AGENDA ITEM SUMMARY / STAFF REPORT**ITEM NO: 4****FLORENCE PLANNING COMMISSION**Meeting Date: *September 12, 2023*

ITEM TITLE:*Resolution PC 23 22 CUP 05*
Wild Mushroom Processing and Distribution Facility

**FINDINGS OF FACT
FLORENCE PLANNING COMMISSION
Exhibit "A" Draft**

Public Hearing Date: September 12, 2023 **Planner:** Clare Kurth
Application: PC 23 22 CUP 05

Off-street Parking & Loading

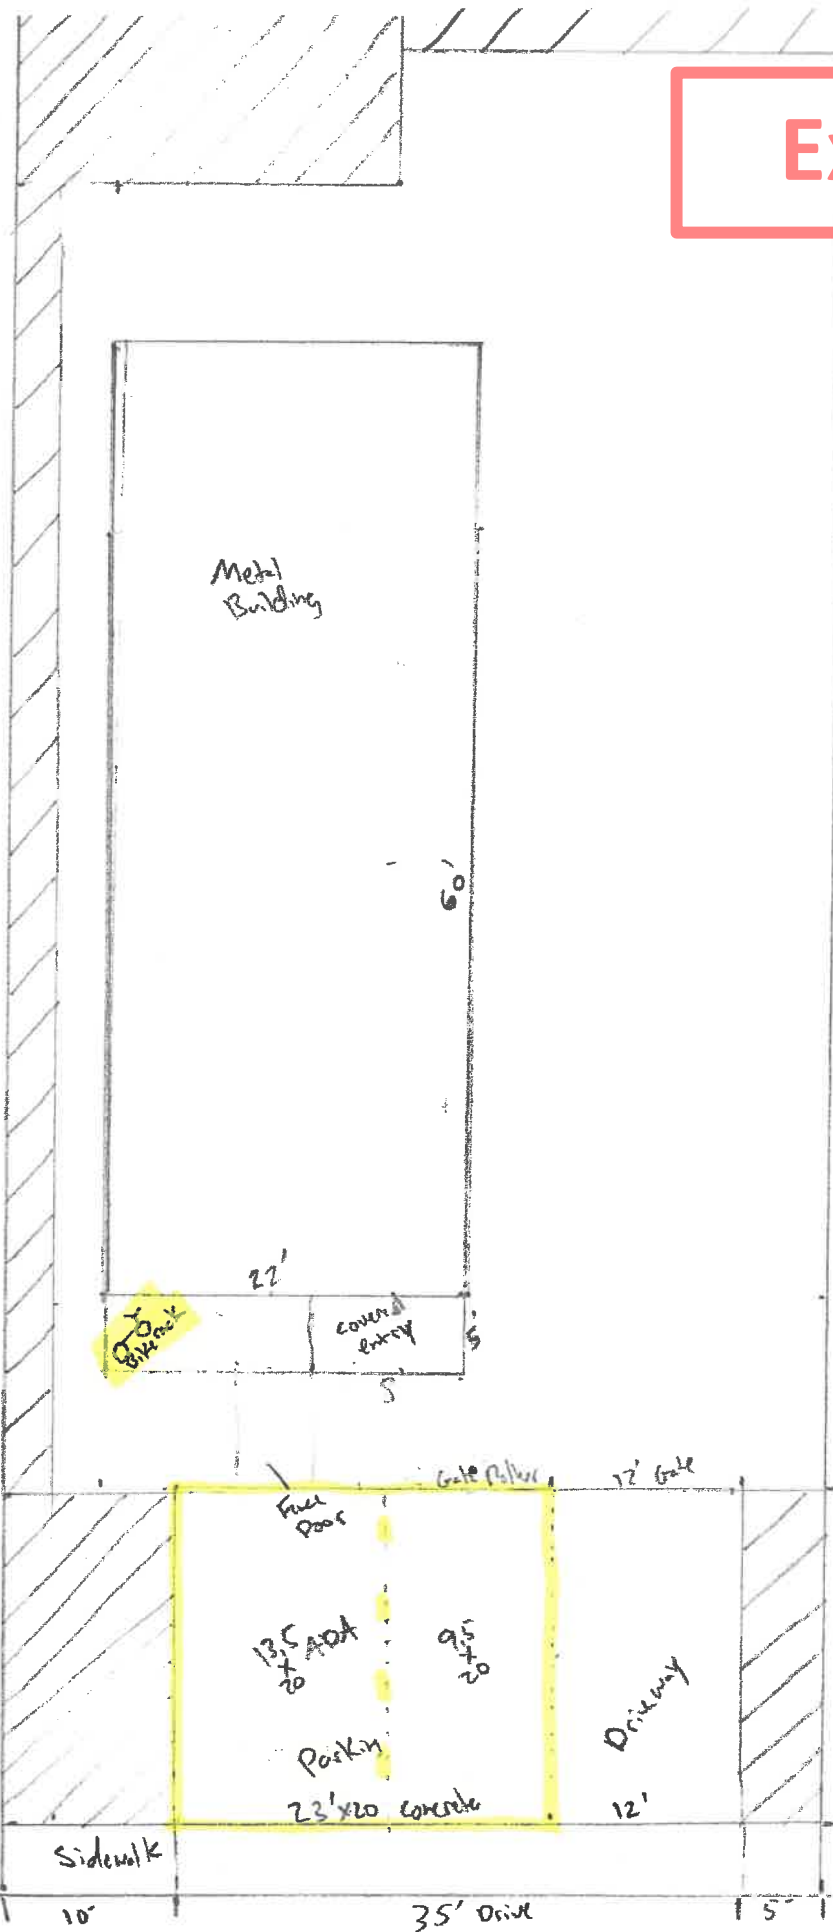
As shown on the submittal, the developer will need to complete sidewalks along the property frontage of 31st Street. Care needs to be taken with the construction of the driveway apron so that all current ADA standards are met. The driveway can incorporate the sidewalk either as a depressed driveway or a sidewalk bypass as shown on City of Florence detail F-205 (standard driveway and sidewalk); F-208 (depressed driveway and sidewalk); F-208A for a driveway with a bypass sidewalk; or F-208B for a fully depressed sidewalk and driveway.
